# Engineering Change Notification

VN-...-Vacuum generators

Project No  
269959

Project Title  
VN-... BMS-TQ  
conector change

Previous Version	Future Version
QS	BMS-TQ

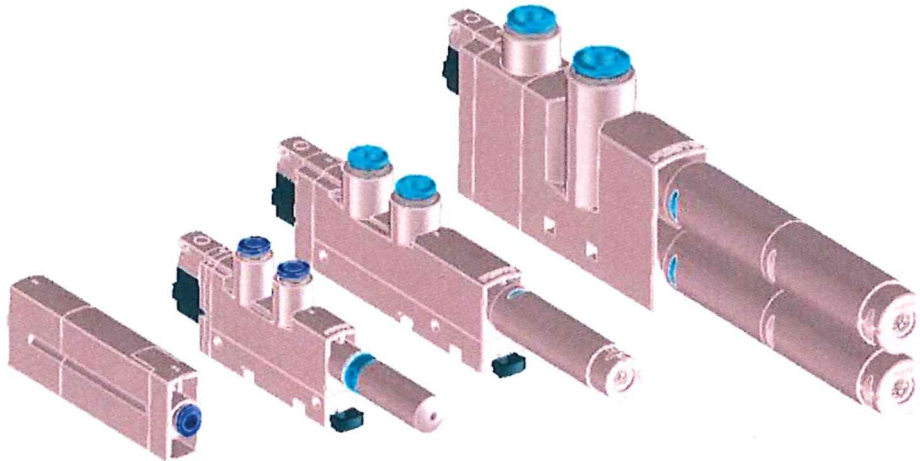
BMS-TQ fitting insert will replace existing QS fitting insert. For change details see pictures below.

Only size 10 displayed but size 6, 8 and 12 will be affected by the change.

New connectors will be shorter and have oval shaped release ring (blue part).
